Public Service Commission State of North Dakota

July 23, 2018

The Reclamation Division has reviewed your concerns regarding your land located in the NW $\frac{1}{4}$ of Section 34, T146N, R88W, as outlined in your May 4, 2018 email. Your property is located off-permit and adjacent to Surface Coal Mining Permit NACT-9501 at the Coteau Properties Freedom Mine.

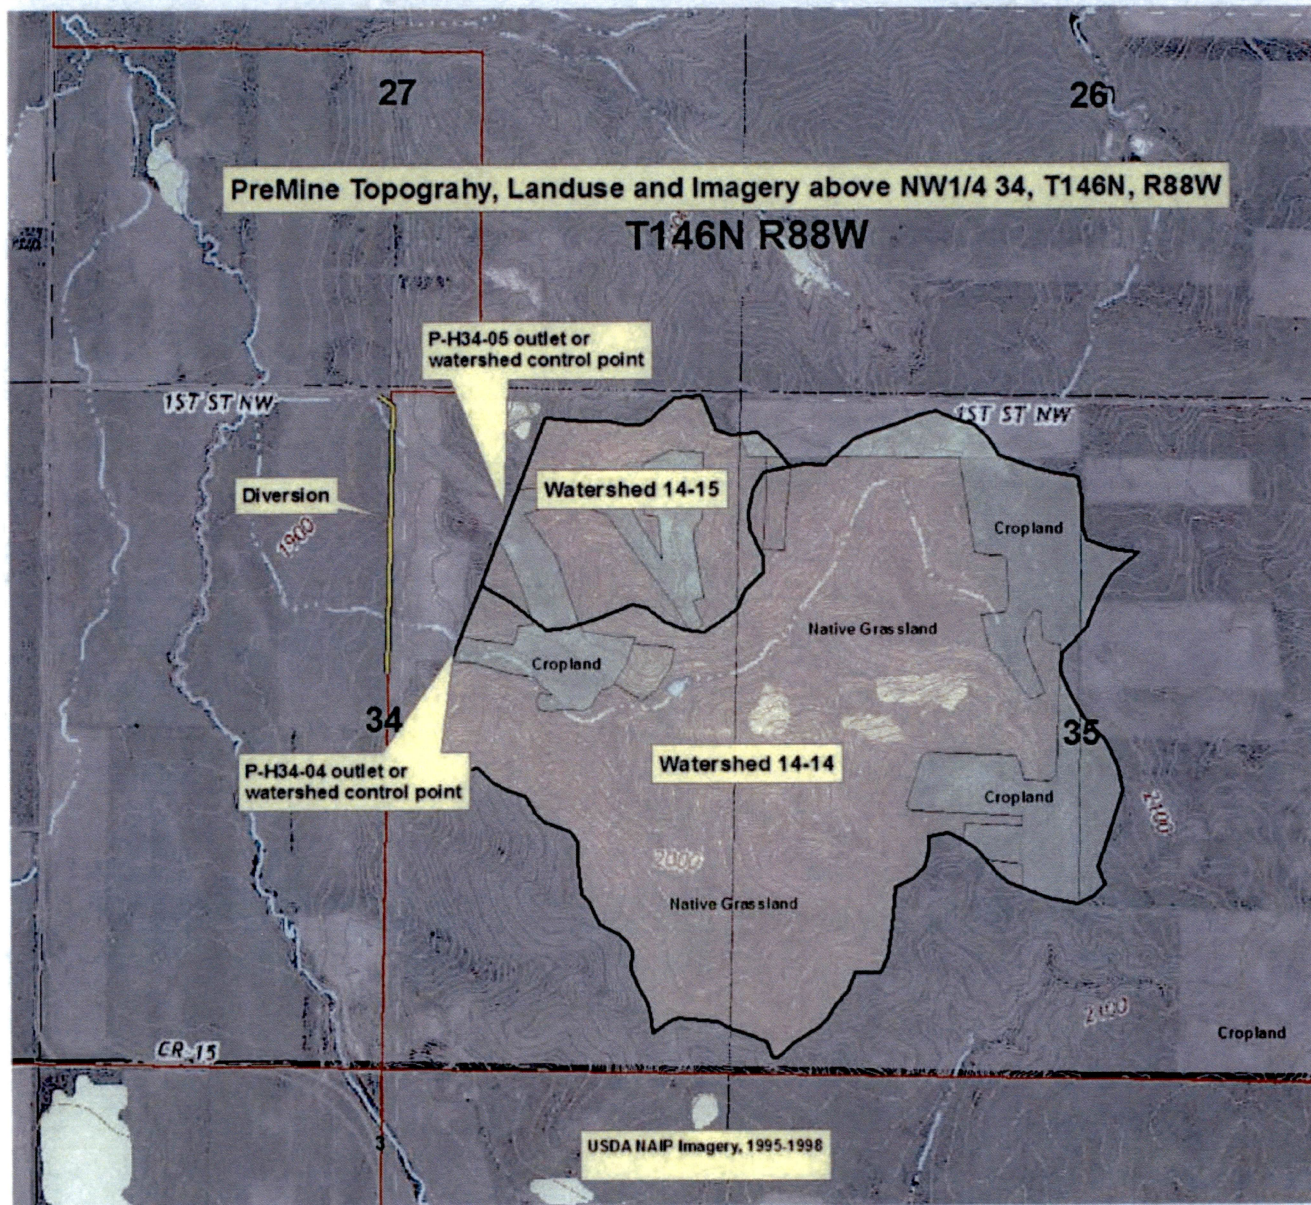
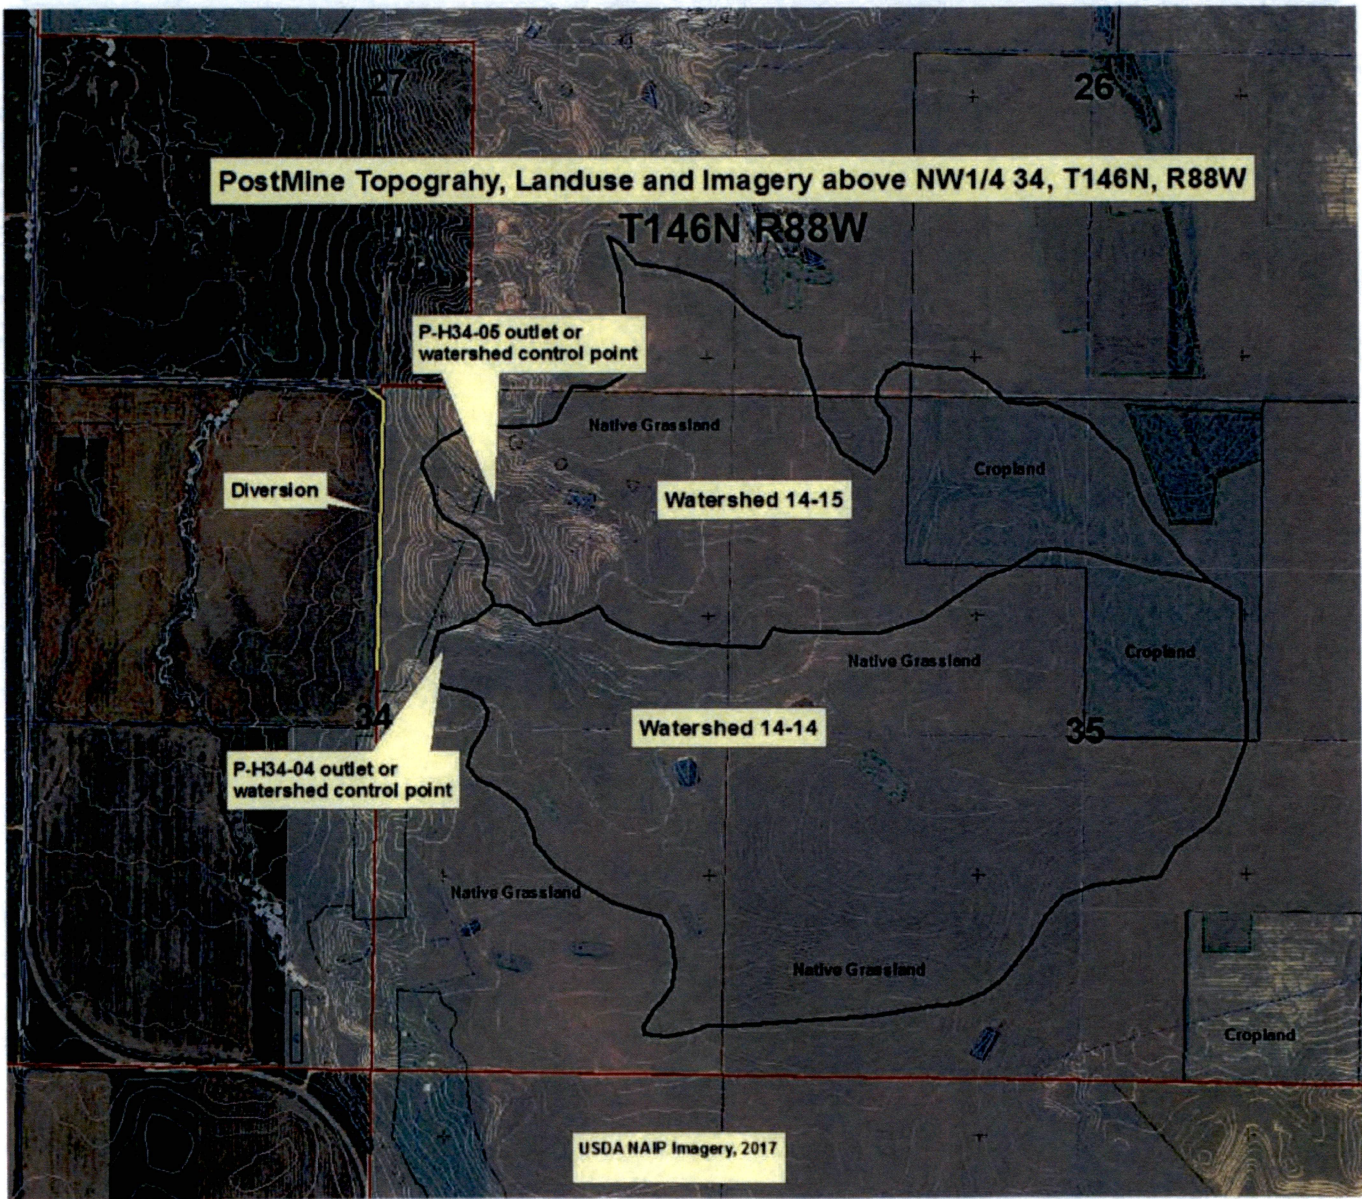
On August 28, 2007, Coteau submitted the application for Revision No. 30 to Surface Coal Mining Permit NACT-9501. This revision proposed changes to the postmine topography and watershed boundaries in the NE¼ of Section 34. The size of watershed 14-14 (most of the area controlled by sediment pond P-H34-04) decreased slightly (5 acres smaller than premine) but the size of watershed 14-15 (most of the area controlled by sediment pond P-H34-05) was increased by 132 acres. The combined area of watersheds (14-4 and 14-15) increased by a total of 127 acres. Revision No. 30 also proposed some land use changes for the NE¼ of Section 34 including changing the postmine land use of a portion of the watersheds from cropland to native grassland. Attached are maps depicting pre- and post-mine watersheds 14-14 and 14-15.

Our analysis shows that even though the total combined watershed size increased after reclamation, the expected total flow rates and volumes are less than the premine condition. This is due to a number of reasons but is primarily due to the reclaimed or postmine watersheds being less steep than the premine watersheds. The premine average slope of watershed 14-15 was 12.7% and the postmine average slope is 4.4%. In addition, the shallow and claypan soils that were common in the premine watershed were replaced with deeper, loamy soils with higher infiltration rates. In addition, there is less cropland and more native grassland in the reclaimed watershed than in the premine watershed. The perennial native grassland vegetation generally has a lower runoff potential than cropland.
